Dunedin City District Plan
DISTRICT PLAN CHANGE 10
Transportation Rules and Definitions
Decision Incorporating Submissions

29 September 2010

Figure 20.1 Minimum separation distance between residential unit and vehicle access

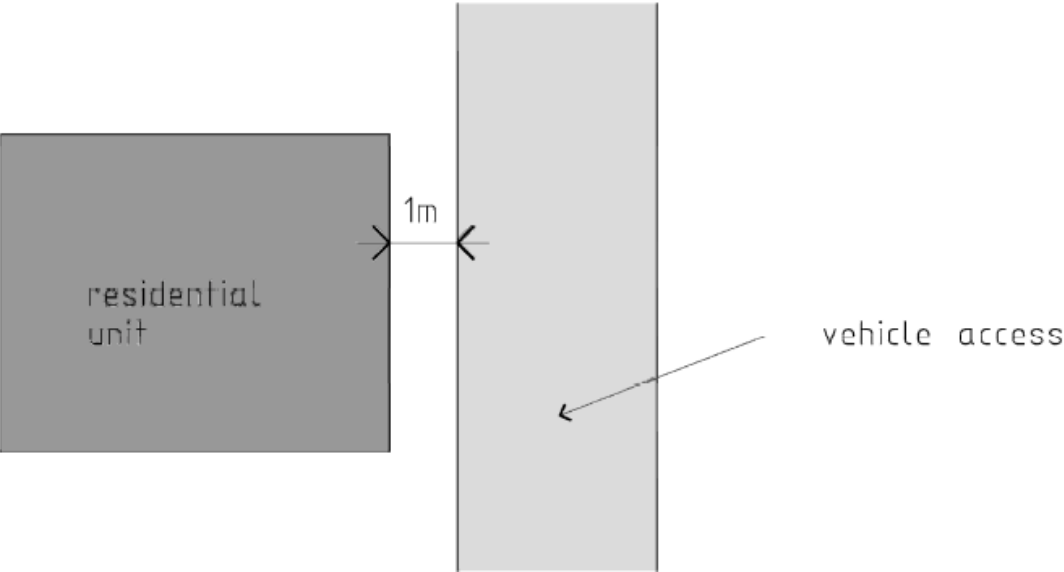
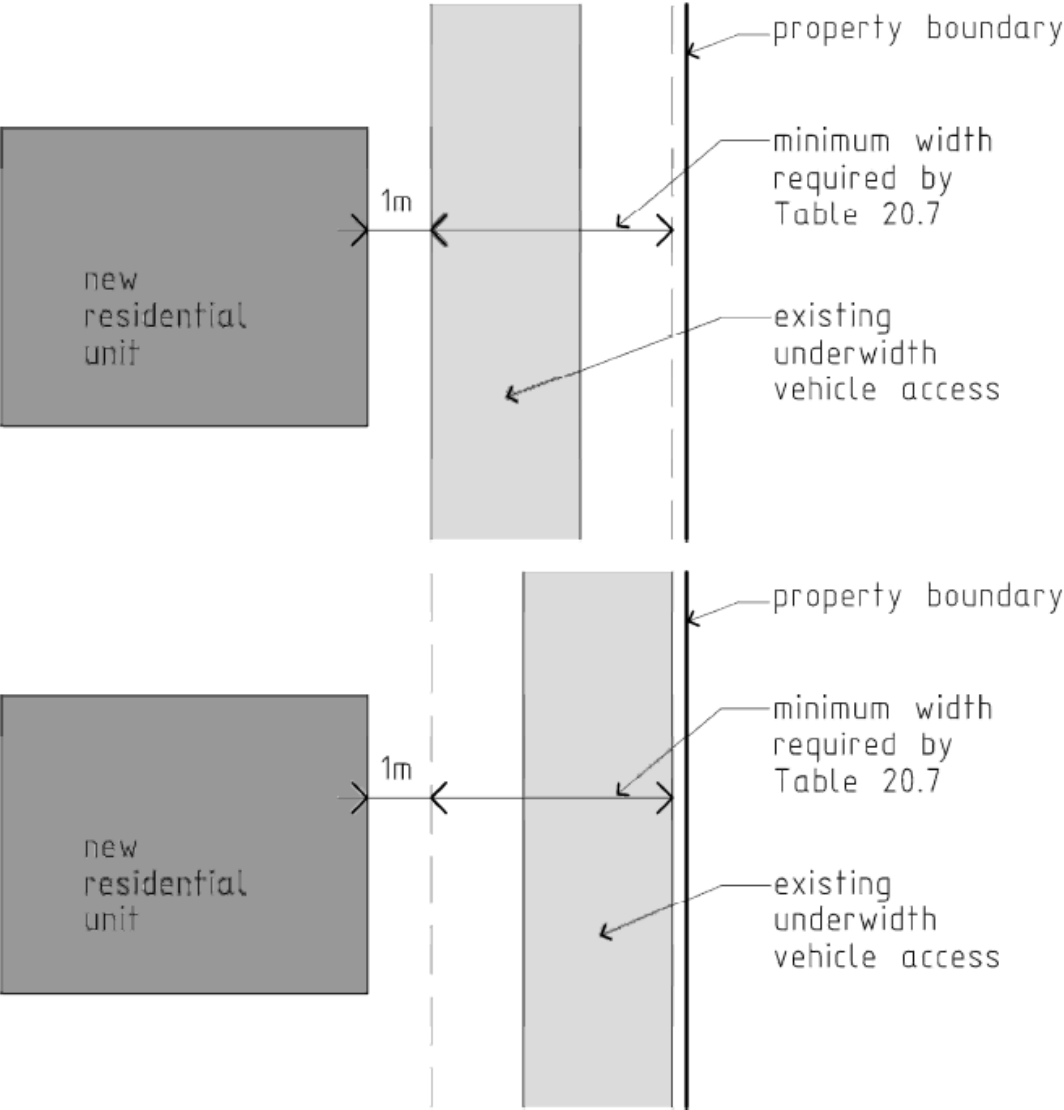
Regarding the submission of **City Planning (PC-10-2)**, the Committee accept that the 1m separation distance should be required regardless of whether opening doors and windows may obstruct a vehicle access, and that the proposed revision to Rule 20.5.7(iv)(f) is appropriate to address the issues identified in the submission. However, we consider that some minor amendments to the wording proposed by **City Planning** will increase the clarity of the rule. Most notably, the rule should specify that the 1m separation distance applies between the dwelling and the formed width (rather than the legal width) of the vehicle access. It should also be noted that in cases where a new dwelling is proposed adjacent to an existing under-width access, the positioning of the new dwelling must allow the minimum 1m distance to be maintained in the event that, in the future, the width of the access is increased to the minimum required width as set out in Rule 20.5.7(v)(b). Finally, diagrams should be added to illustrate this rule.

(f) Except as specified in Rule 20.5.7(iv)(i), there shall be a minimum distance of one metre (as shown in Figure 20.1) between a residential unit and a formed vehicle access where:

As shown in Figure 20.2, where an existing formed vehicle access does not comply with the minimum required formed width specified in Table 20.7 of Rule 20.5.7(v)(b), a new residential unit shall be positioned to provide:

Figure 20.1 Minimum separation distance between residential unit and vehicle access

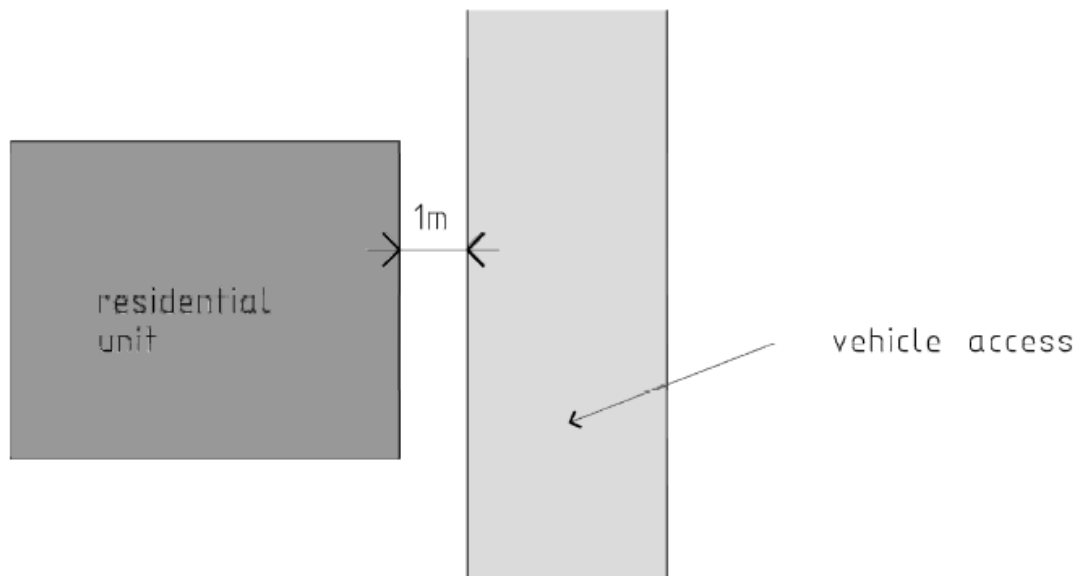
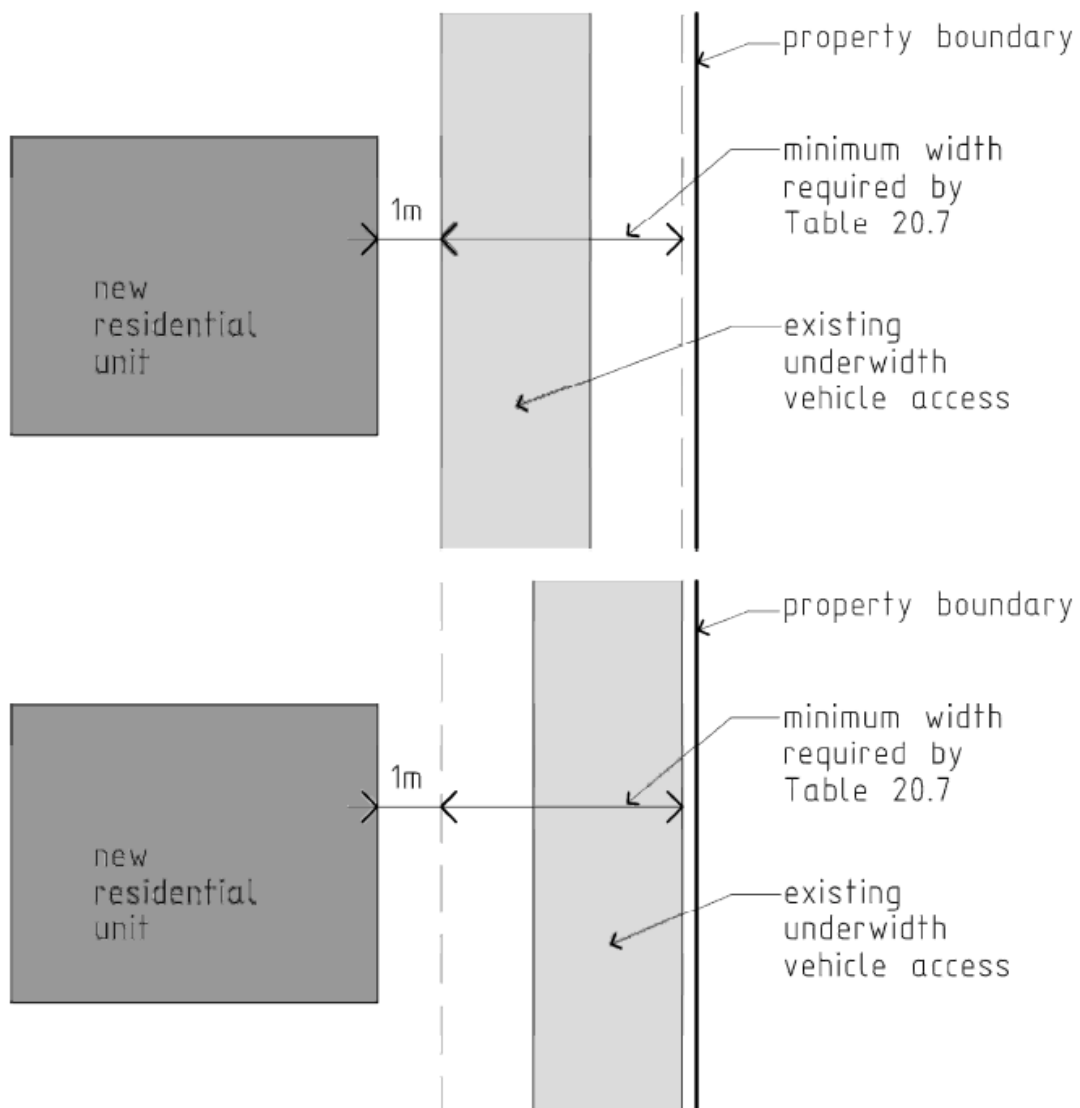
- (f) Except as specified in Rule 20.5.7(iv)(i), there shall be a minimum distance of one metre (as shown in Figure 20.1) between a residential unit and a formed vehicle access where:

As shown in Figure 20.2, where an existing formed vehicle access does not comply with the minimum required formed width specified in Table 20.7 of Rule 20.5.7(v)(b), a new residential unit shall be positioned to provide:

- The minimum one metre distance required by this rule, and
- Sufficient space to increase the formed width of the access to comply with Table 20.7.

Figure A.1: 99 percentile design motor vehicle dimensions

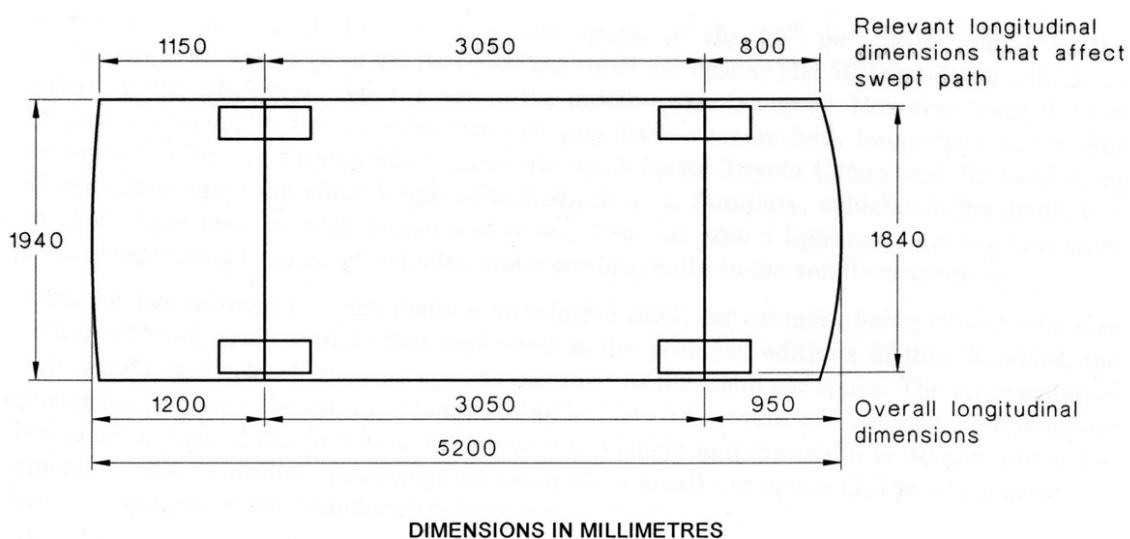
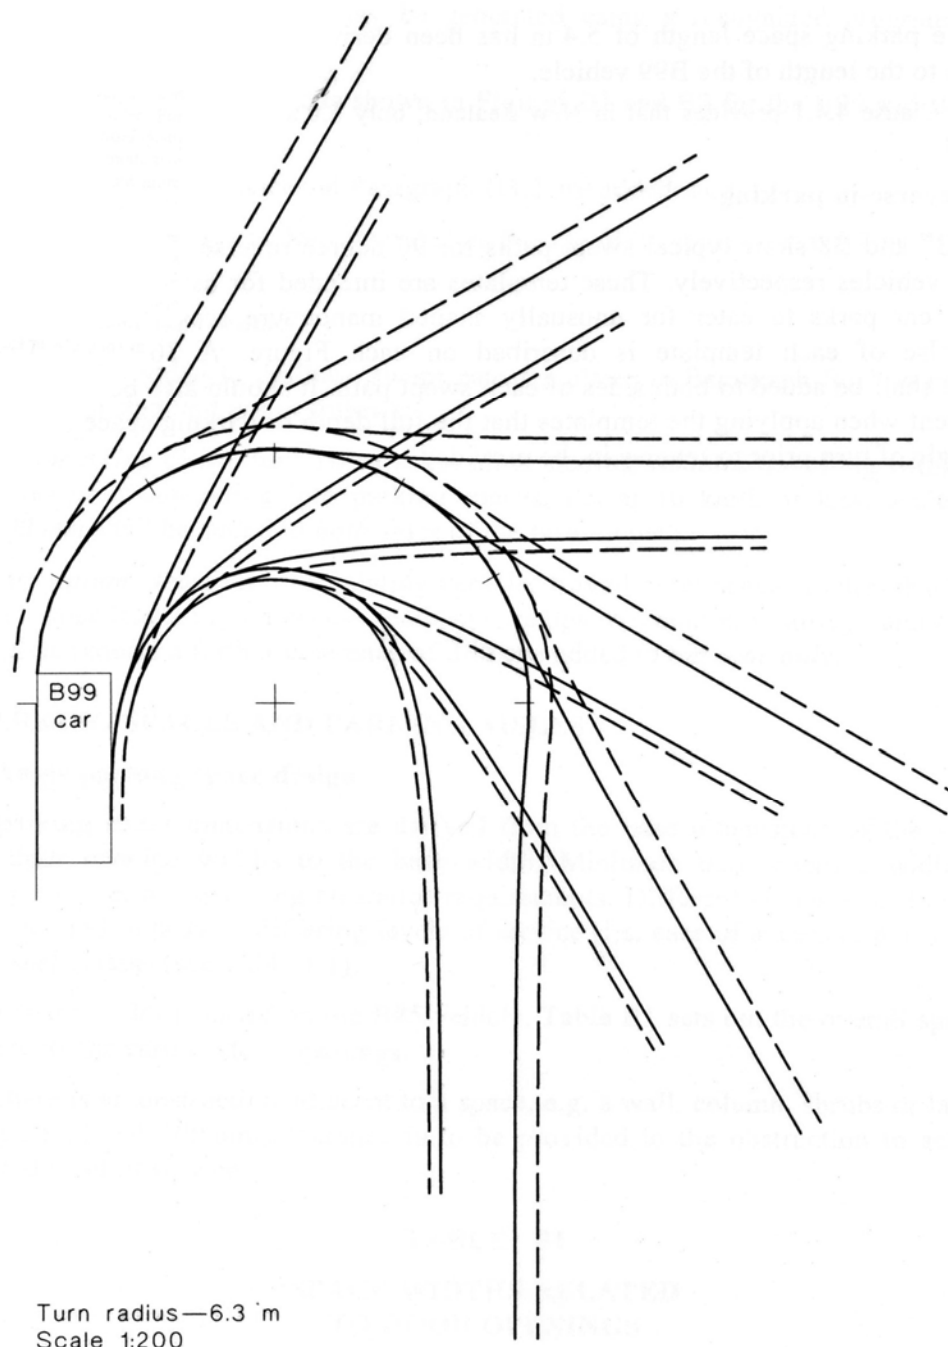
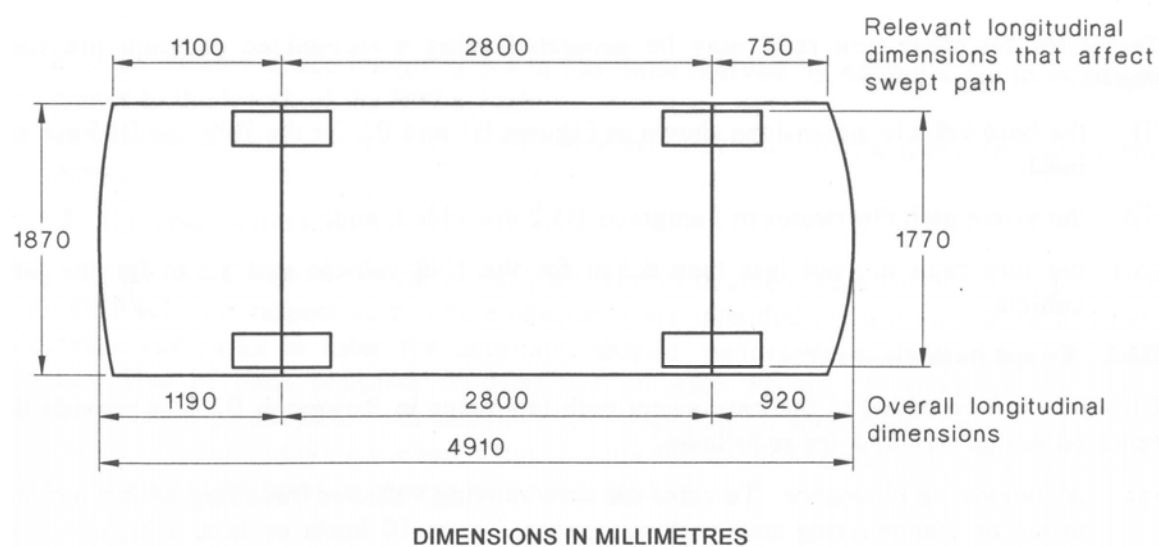
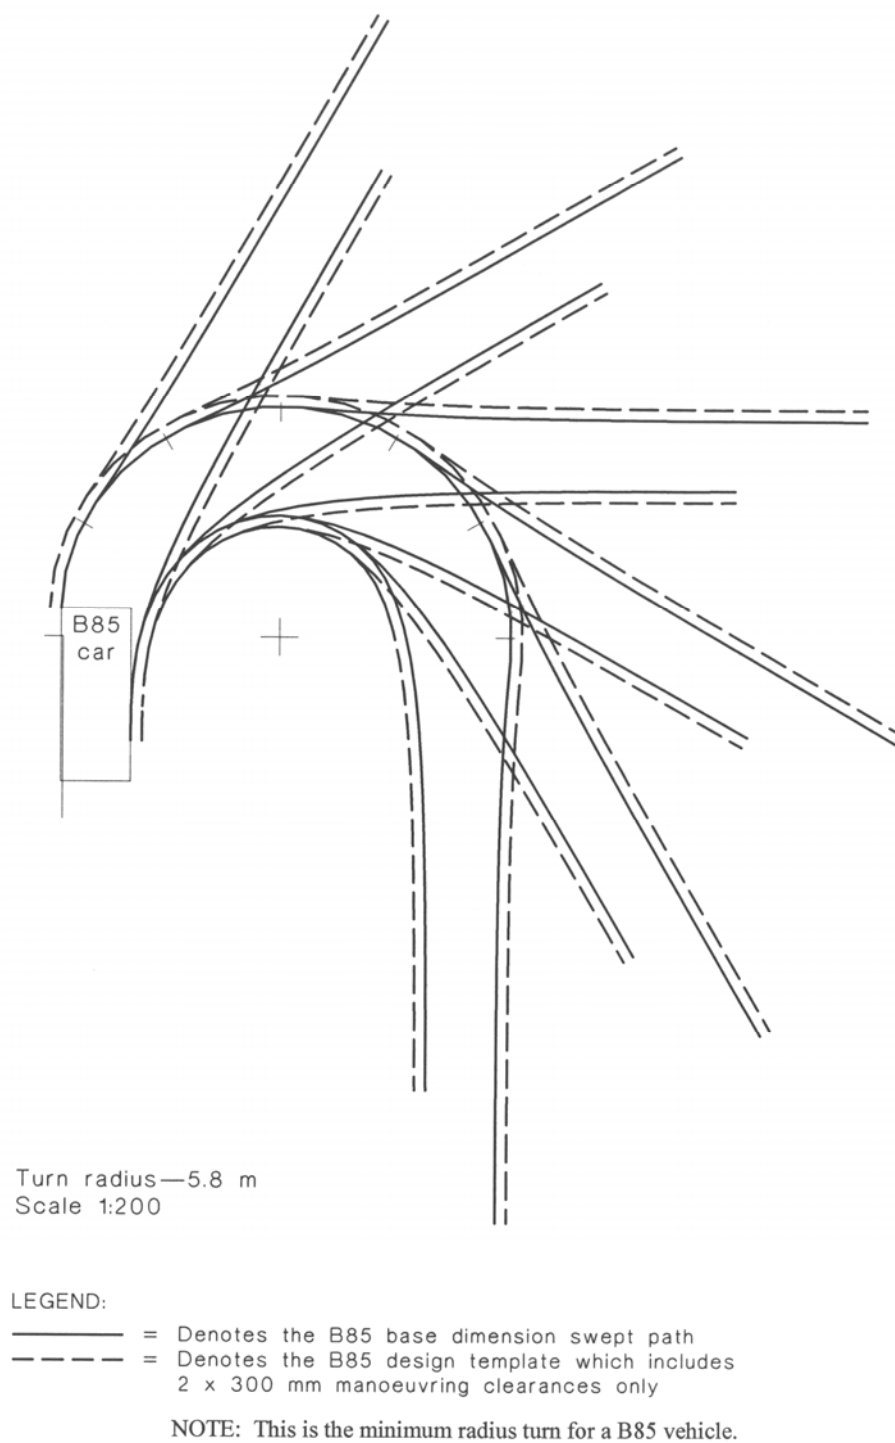
Plan Change 10 as notified proposed that required parking and manoeuvring space should be designed to accommodate a 99 percentile vehicle with 6.3m turning radius, as shown in AS/NZS 2890.1:2004. This would result in an increase in the stall depth required for 60° and 90° parking spaces, although required manoeuvring space and parking aisle width would be reduced in comparison to requirements in place in the operative Plan. In response to submissions, further consideration was given to this matter, to establish whether an alternative option could be identified that would minimise increases in required parking stall lengths.

- (b) Replace Appendix 20B Minimum Car Parking Space Dimensions and Appendix 20C 99 Percentile Motor Vehicle with the amended appendices as indicated in Appendix A of this report.

Method to Determine Minimum Distance Between Vehicle Crossing and Intersection

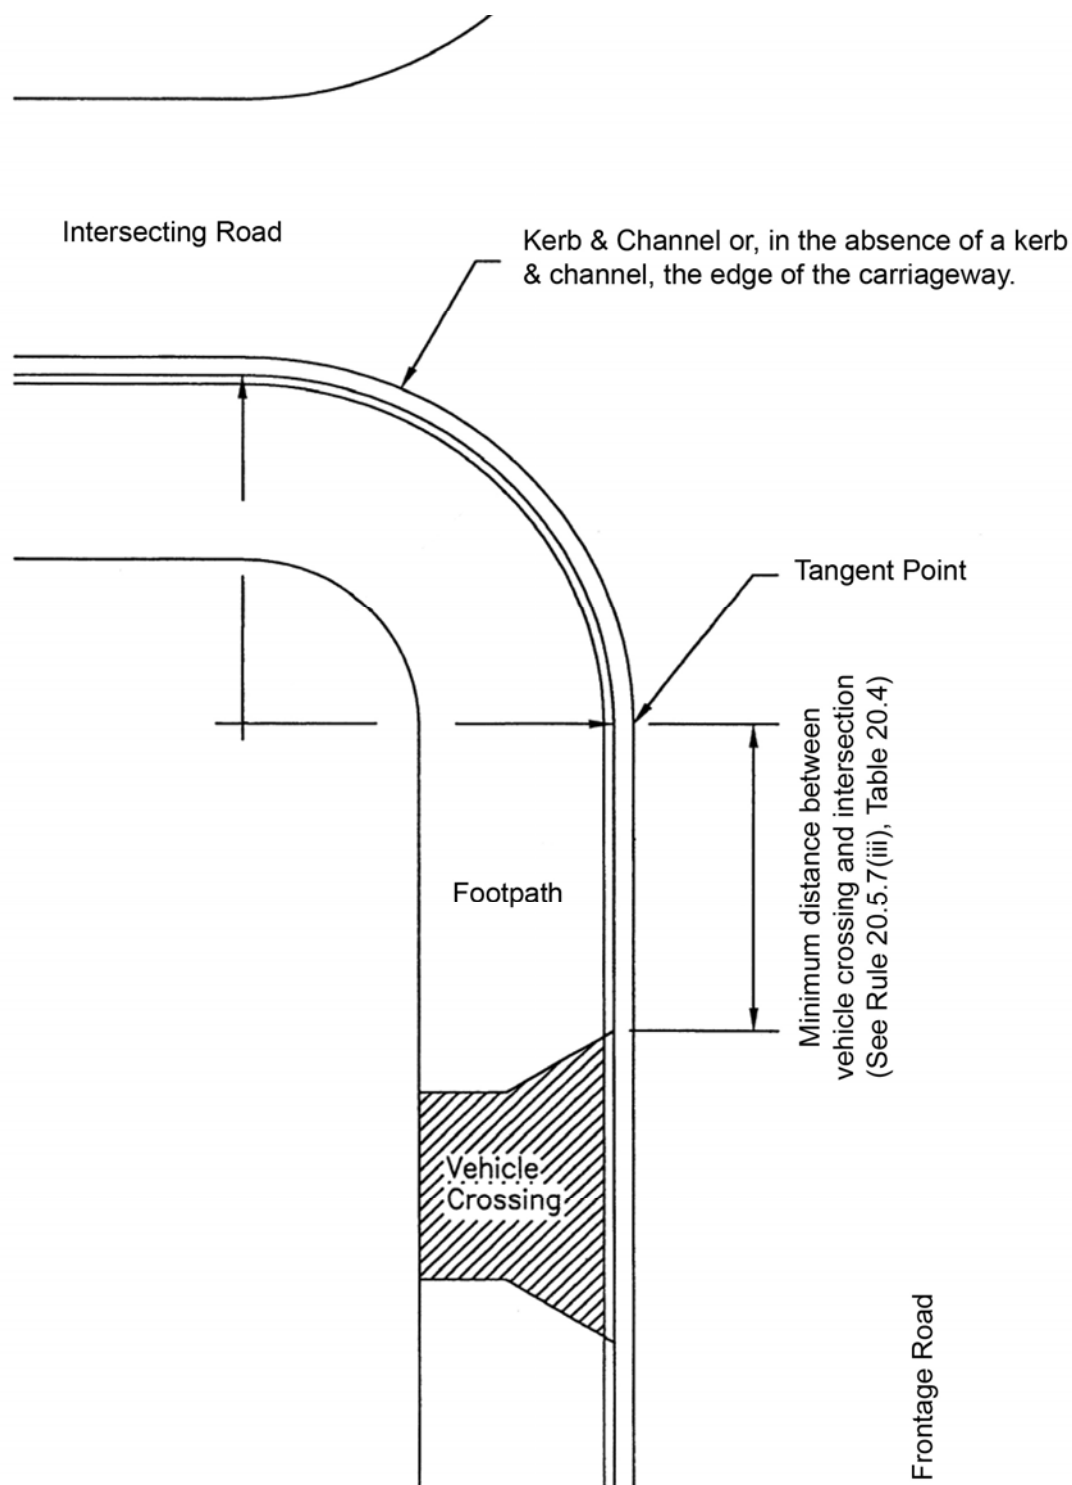
The purpose of the proposed change to Rule 20.5.7(iii)(a) and Appendix 20J is to clarify how distances between vehicle crossings and intersections should be measured. The existing wording of Rule 20.5.7(iii)(a) is difficult to interpret, and no diagram is provided to illustrate the rule. Currently, the distance is to be measured from the vehicle crossing to the 'kerb line, or formed hard surface edge' of the intersecting road. However, it is not always clear where the kerb line or edge begins. The diagram provided in new Appendix 20J clarifies this. As noted by **Mr Wallis (PC-10-7c)**, the effect of clarifying the method will be to increase the overall distance required in some cases. However, the increase will not be significant. The Committee consider it appropriate to retain the minimum distances set out in Table 20.4 of Rule 20.5.7 as notified.
